Formal objection to the discharge of tree-protection details

Application 2026/44/92074/W • Condition 9: Arboricultural Method Statement and Tree Protection Plan

Application	2026/44/92074/W
Site	Land at Occupation Lane, off Birkby Road, Huddersfield, HD2 2ES
Applicant	Longwood Property Management (UK) Ltd
Agent	Northlight Architectural Consultants
Case officer	Ellen Gilbert
Objector	
Date	10 September 2026

Neighbouring hedge — severe recent cutting and apparent decline

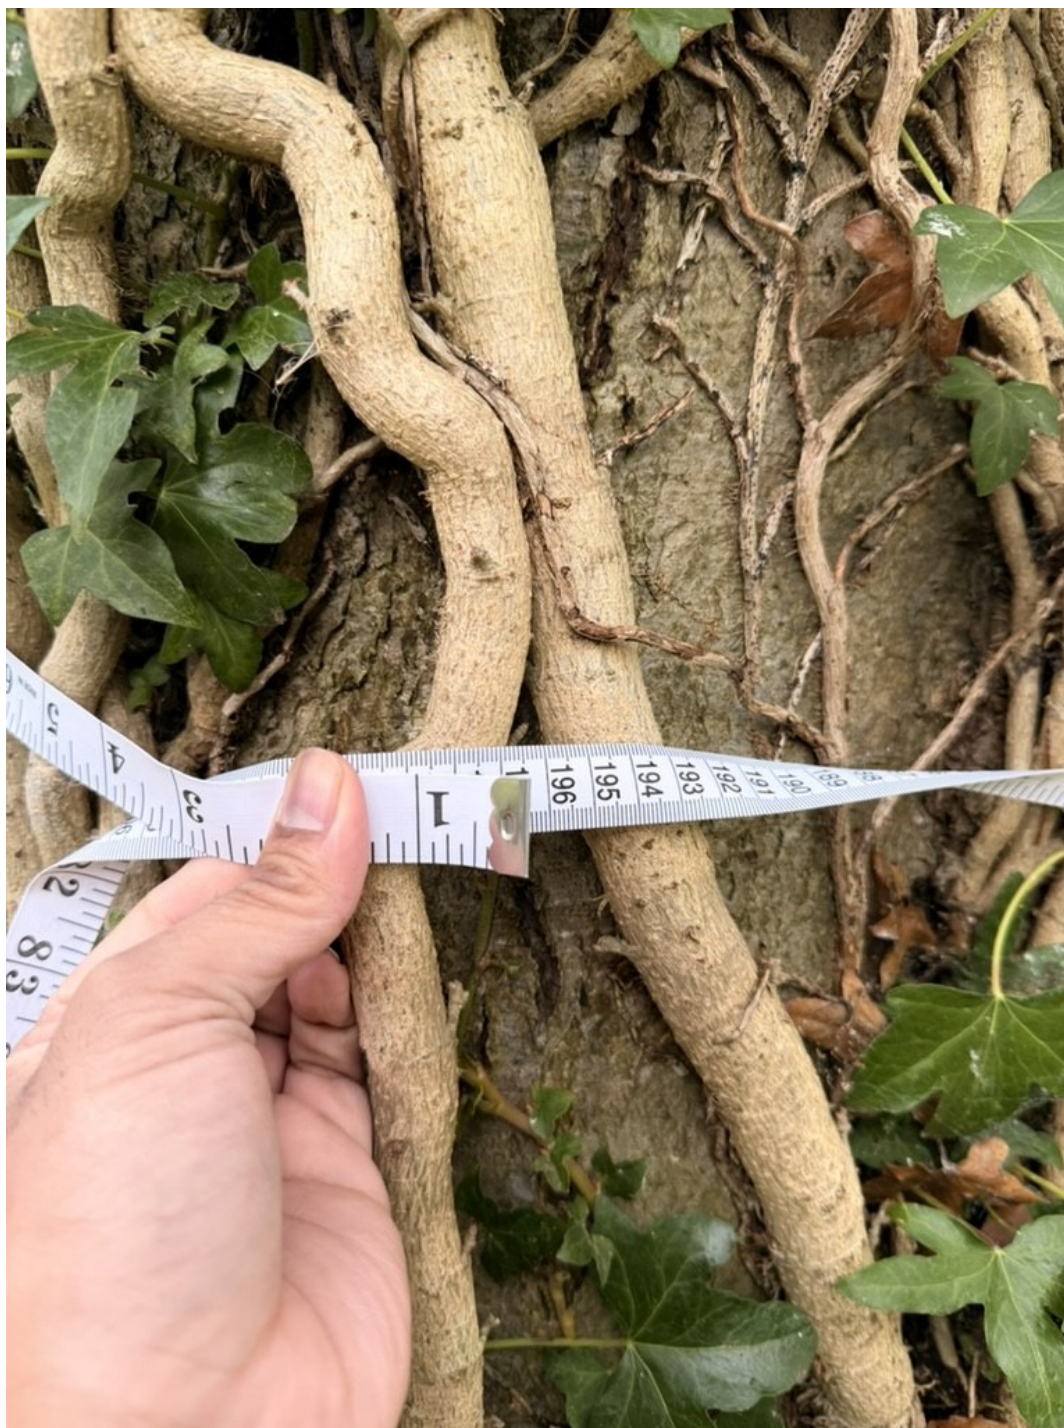
The further photograph at Appendix A6, taken on 10 September 2026, shows that a substantial length of neighbouring hedge has recently been cut back to exposed upright stems, with little foliage remaining across the cut face. I have observed that this hedge/tree vegetation has died or suffered serious decline following the developer's cutting. The photograph corroborates the extent of the cutting, although present viability and the precise cause of decline should be inspected by the Council's Tree Officer. This is additional evidence of ongoing cumulative harm to screening, green character and potential wildlife habitat while the Council is being asked to approve a scheme involving further tree work.

A6. Current view of the development site showing a substantial length of neighbouring hedge cut back to exposed upright stems, with limited foliage remaining across the cut face. I report that the vegetation has died or seriously declined following the developer's cutting. The photograph demonstrates the extent of intervention; the Council's Tree Officer should inspect and determine present viability, causation and the restoration or replacement required.

10. Investigate the recent severe cutting to the neighbouring hedge shown at Appendix A6, including its ownership, the authority for the work, its present viability and what restoration or replacement is required.

T6 — field measurement discrepancy

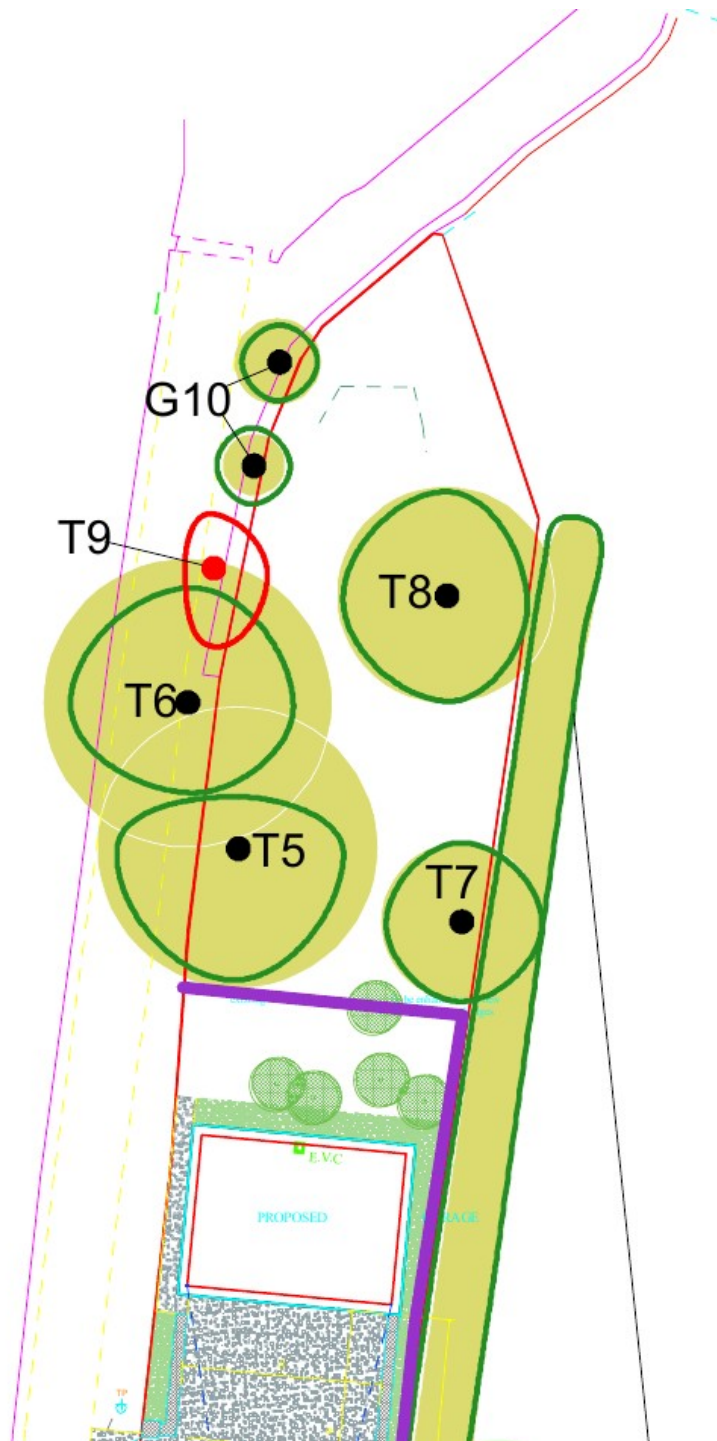
The JCA schedule records T6, a mature whitebeam, with an estimated stem diameter of **46 cm**. The photographic field measurement at Appendix B appears to record a circumference of approximately **197 cm**, equivalent to a diameter of about **63 cm** (circumference ÷ π). This is around 17 cm, or approximately 37%, larger than the report’s estimate.

B1. The tape appears to record a circumference of approximately 197 cm, equivalent to about 63 cm diameter. The JCA schedule gives an estimated diameter of 46 cm. The Council should require a compliant independent measurement and update all root-protection calculations.

Because stem diameter is a central input to the Root Protection Area calculation under BS 5837, the Council should not rely on the estimated figure. T6 should be measured independently at the correct point and the TPP, construction exclusion zone and all associated working methods recalculated and revised if necessary.

6. Independently verify T6's stem diameter and recalculate its Root Protection Area and construction exclusion zone.
7. Require proof of ownership, authority and consent for all proposed work to T3 and any other third-party tree.
